RE: **EM-CING-053-190619** – New Cingular Wireless PCS, LLC (AT&T) notice of intent to modify an existing telecommunications facility located 5 Tyler Drive, Franklin, Connecticut.

June 21, 2019

Staff has reviewed this exempt modification request for completeness and has identified a deficiency in the Construction drawings (CD) prepared by Hudson design Group, LLC and last revised June 12, 2019. Structural notes on Sheets A-1, A-2, S-1 and S-2 of the CD reference a Mount Analysis and a Structural Analysis both prepared by Hudson Design Group, LLC and dated June 10, 2019 and May 5, 2019 respectively. This is inconsistent with the Structural Analysis and Mount Analysis provided with the request.

AT&T
COMPOUND & EQUIPMENT PLANS
(LTE 2C/3C/4C/5C/4TX4RX)
SITE NUMBER: CT1264
DRAWING NUMBER: A-1
REV: 1

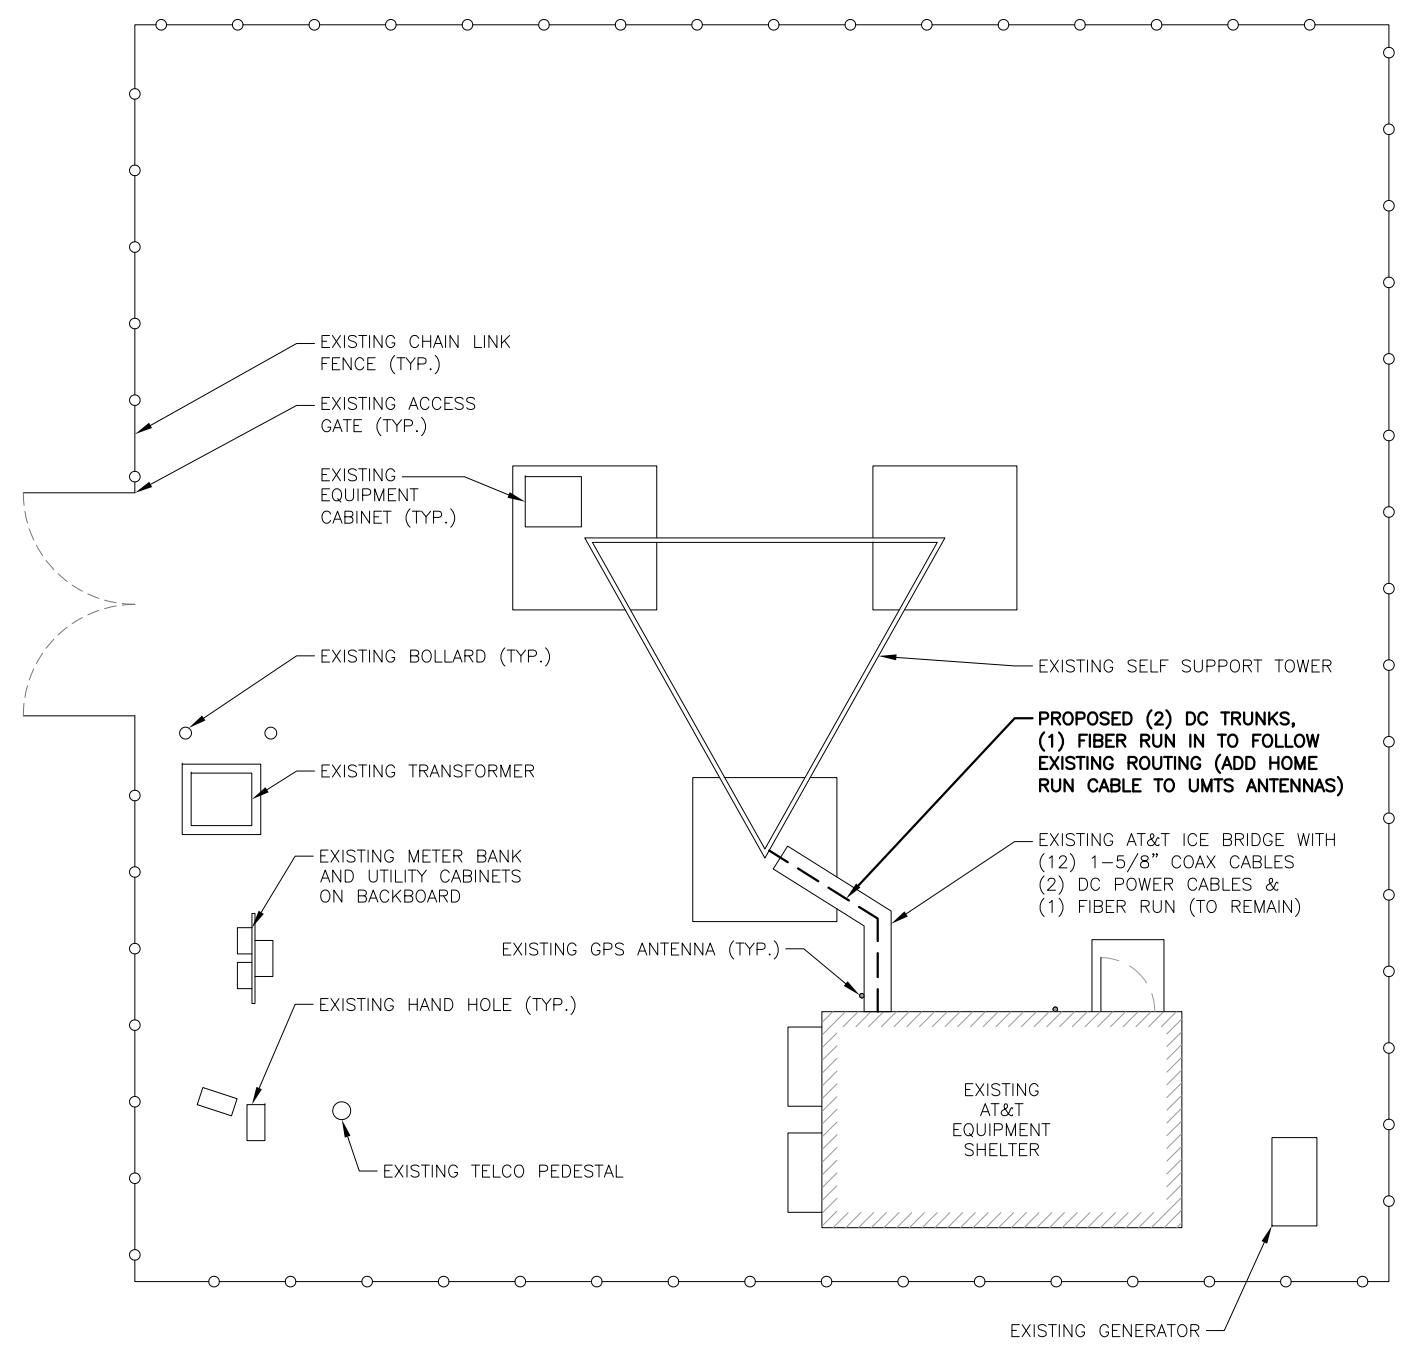
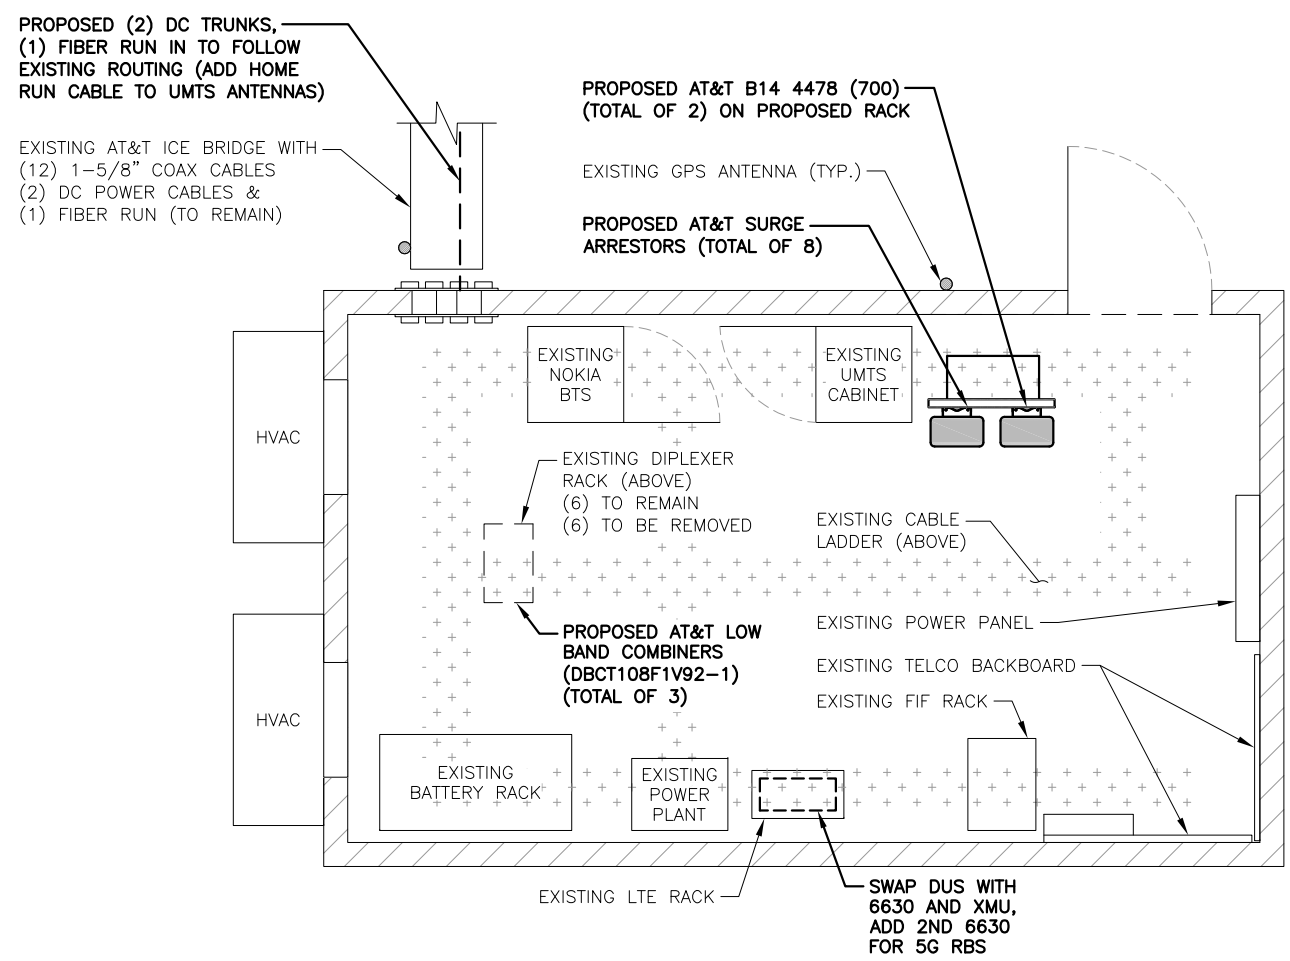
On June 25, 2019, the Council received a CD dated June 12, 2019 which referenced the SA submitted but still referenced the June 10, 2019 (Rev.1) Mount Analysis, which was not provided with the request for exempt modification. The MA submitted with the request is dated March 29, 2019.

Therefore, the exempt modification request remains incomplete at this time. The Council recommends that Centerline Communications provide the MA referenced in the CD, on or before July 26, 2019. If additional time is needed to gather the requested information, please submit a written request for an extension of time prior to July 26, 2019. **Please provide an electronic version and one hard copy of the CD for the incomplete request to be rendered complete and processed.**

Therefore, the exempt modification request is incomplete at this time. The Council recommends that Centerline Communications provide a CD that references the Structural Analysis and Mount Analysis provided in the submittal, on or before July 22, 2019. If additional time is needed to gather the requested information, please submit a written request for an extension of time prior to July 22, 2019. **Please provide an electronic version and one hard copy of the CD for the incomplete request to be rendered complete and processed.**
